## **ADDENDUM TWO**

**Addendum Two** to the drawings and specifications prepared by Myszak + Palmer for **Vigo Elementary Renovations** for **Vincennes Community School Corporation**, Vincennes, Indiana.

FACILITY RENOVATIONS FOR  
**VCSC VIGO ELEMENTARY**  
 PROJECT NO. 16\_26 VINCENNES, INDIANA

**C7.1**  
 RAILING DETAILS  
 PHASE II

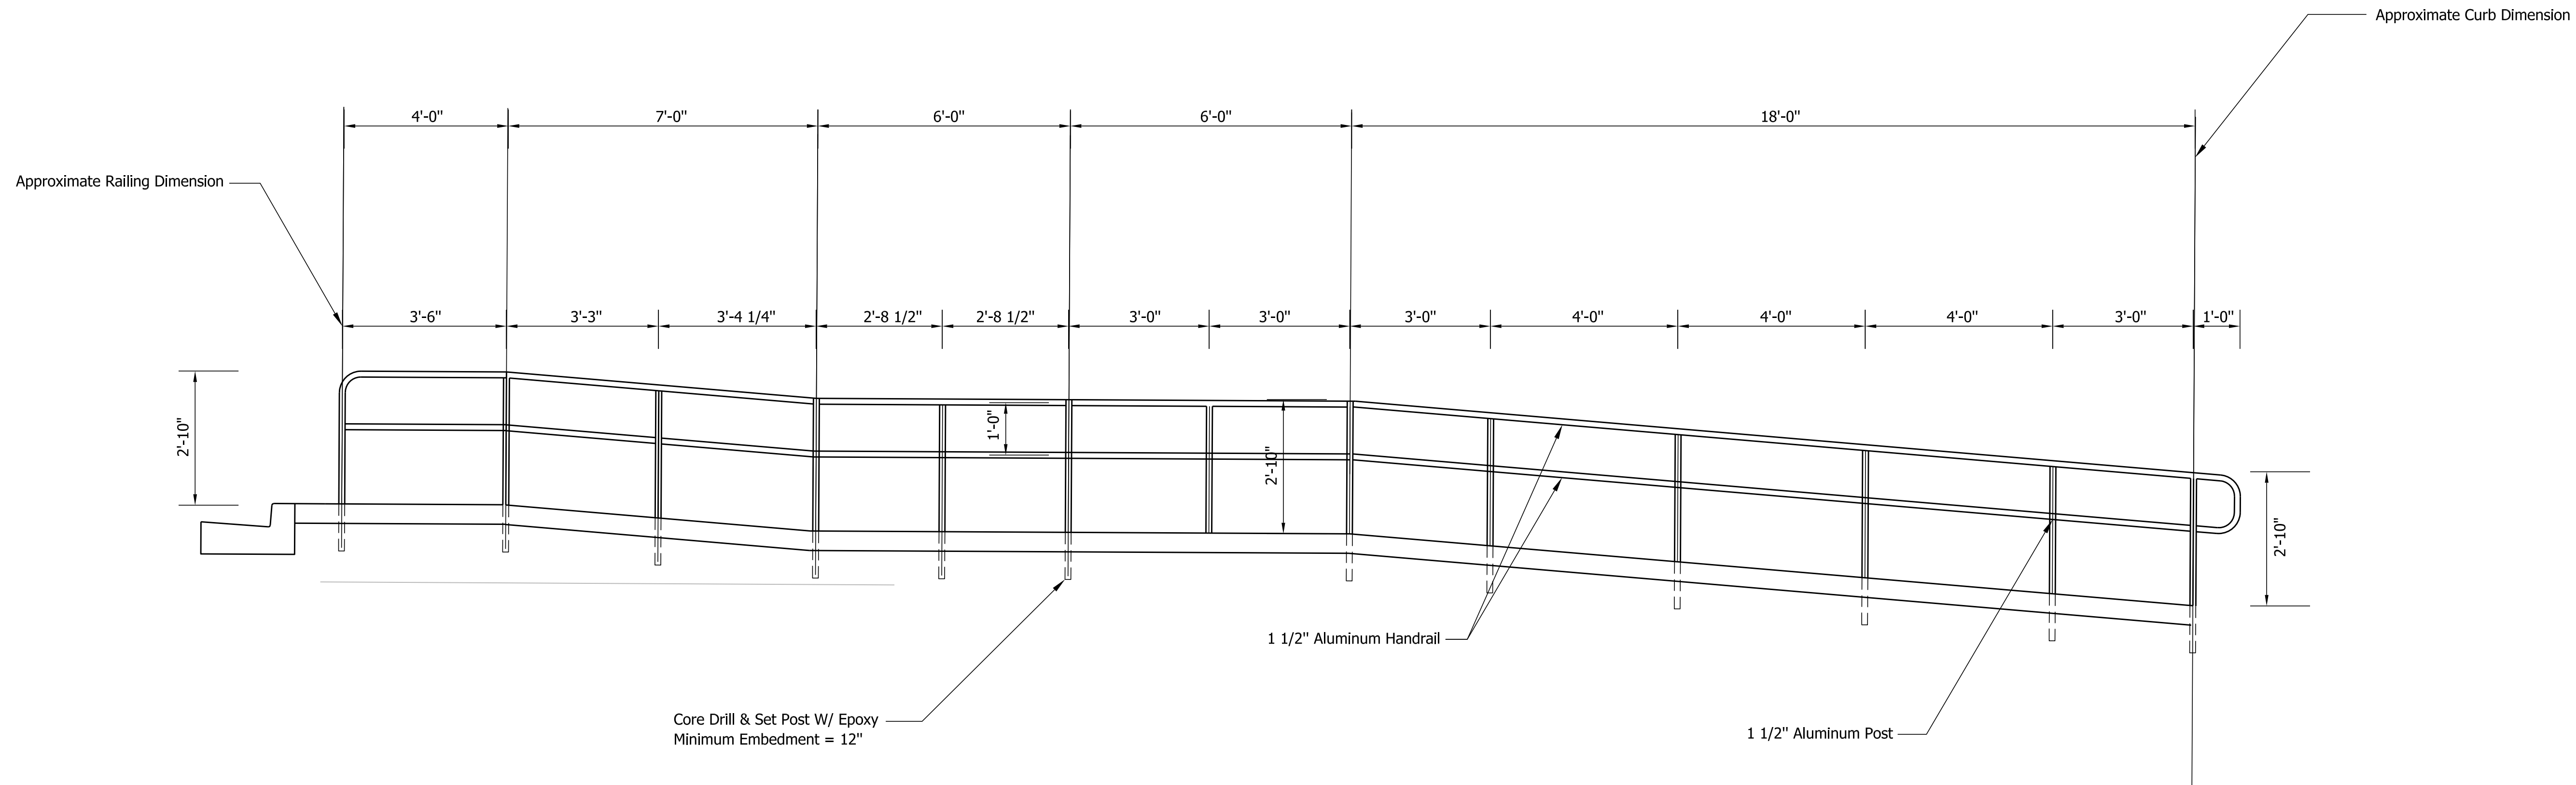
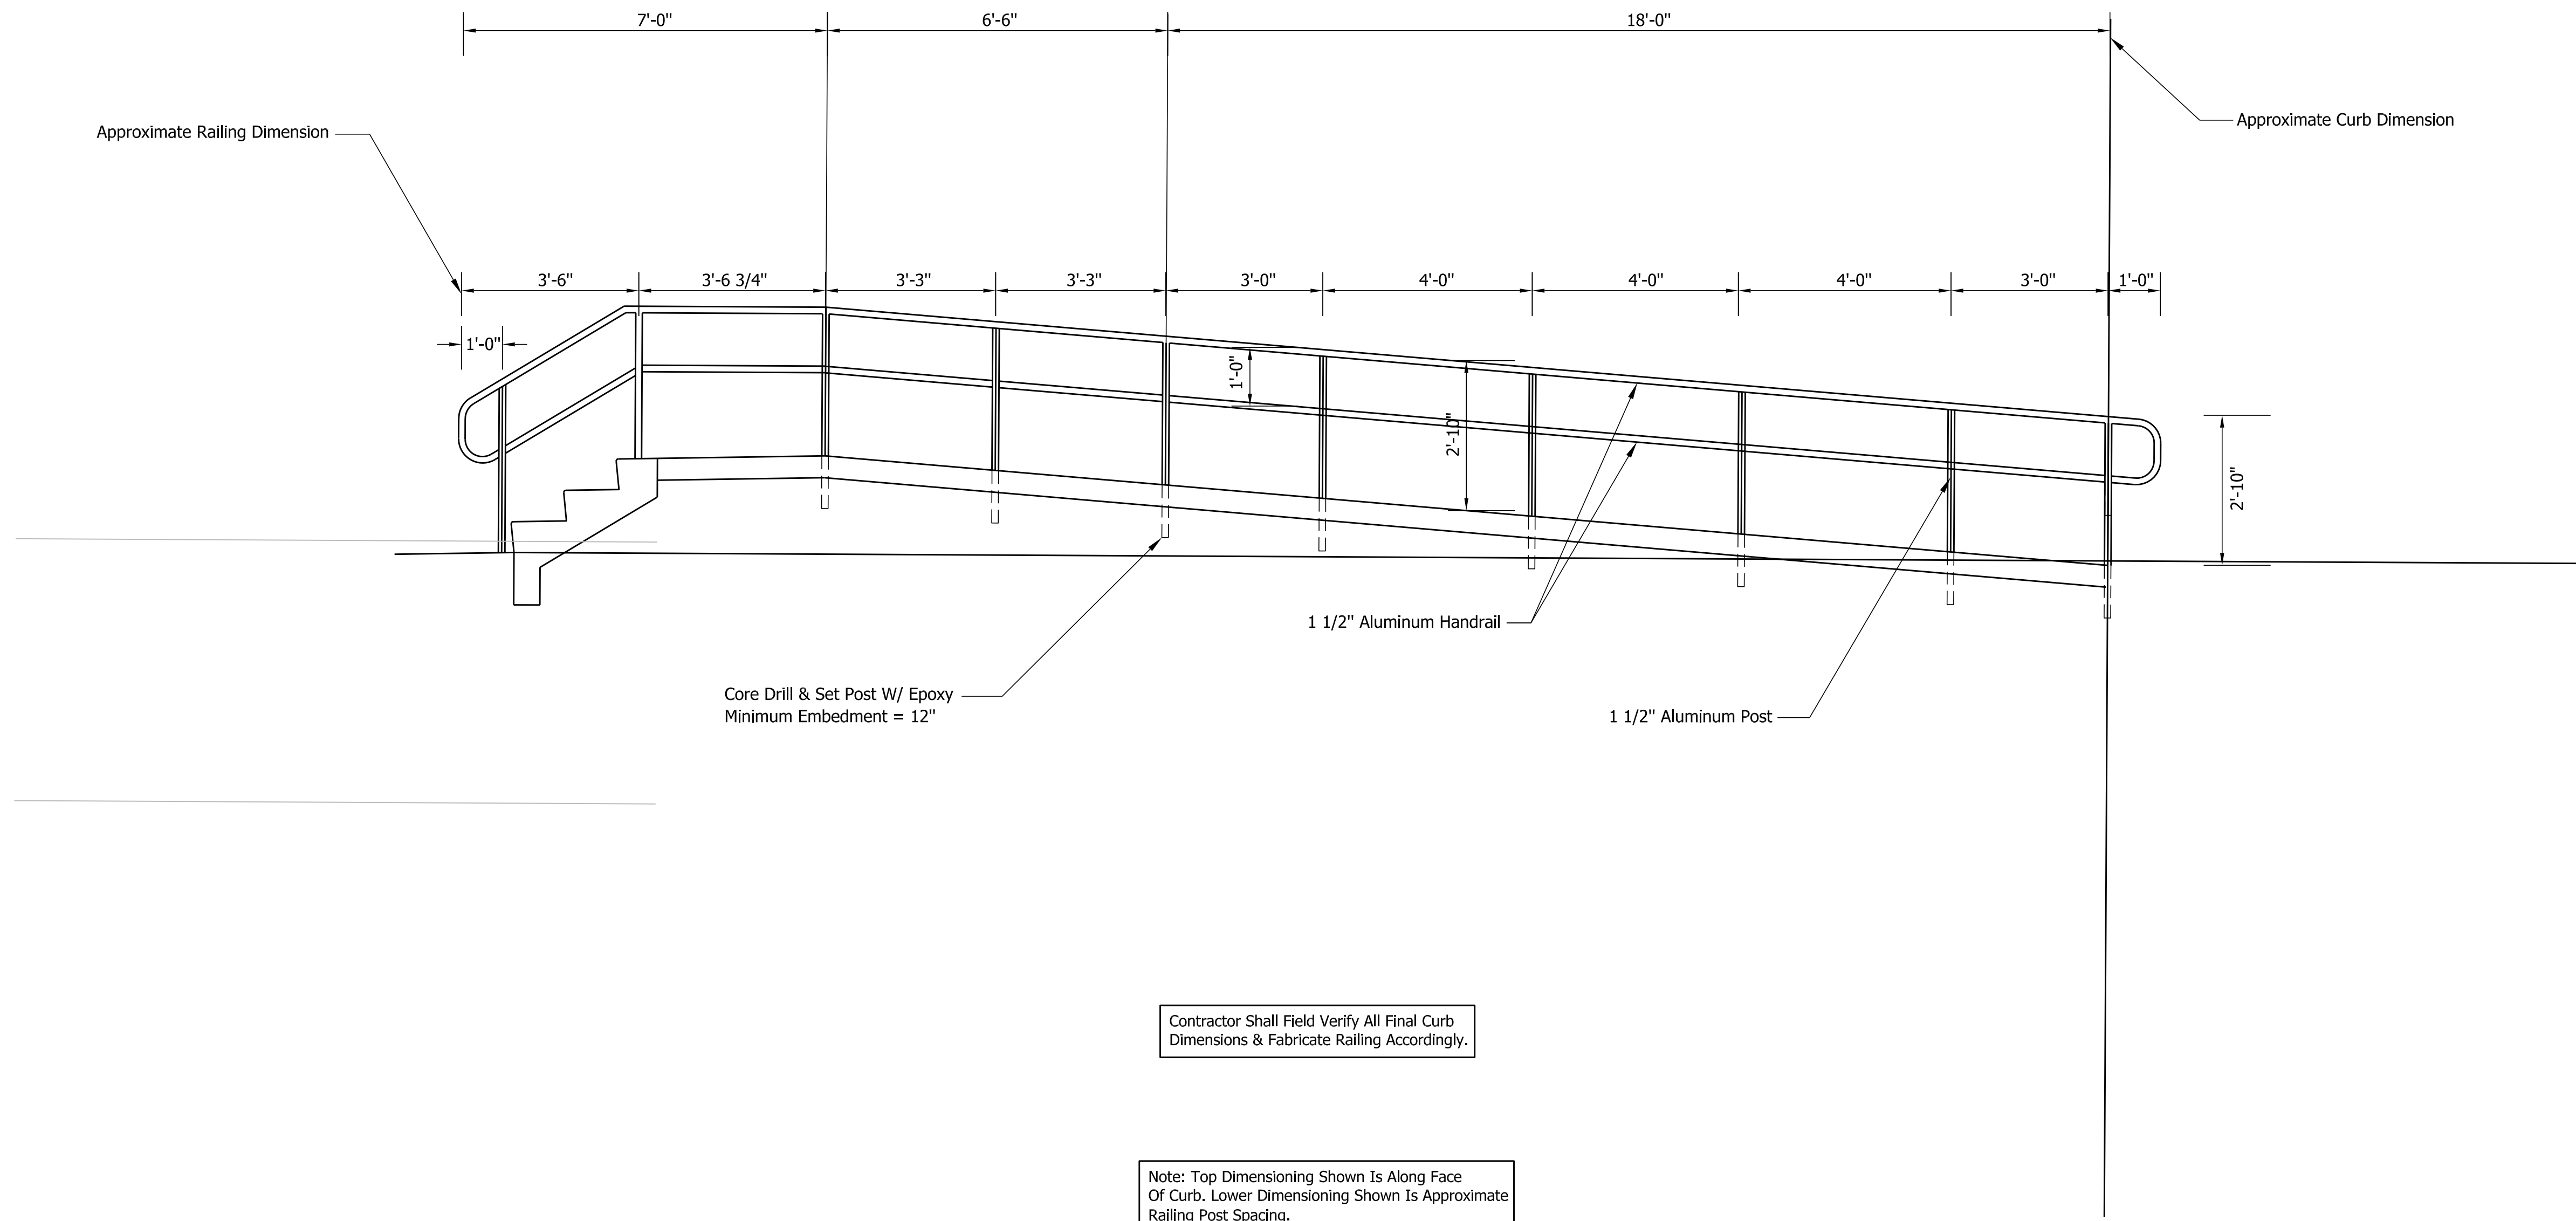
- A. See the attached C7.1 showing the typical exterior ramp and stair railing details.
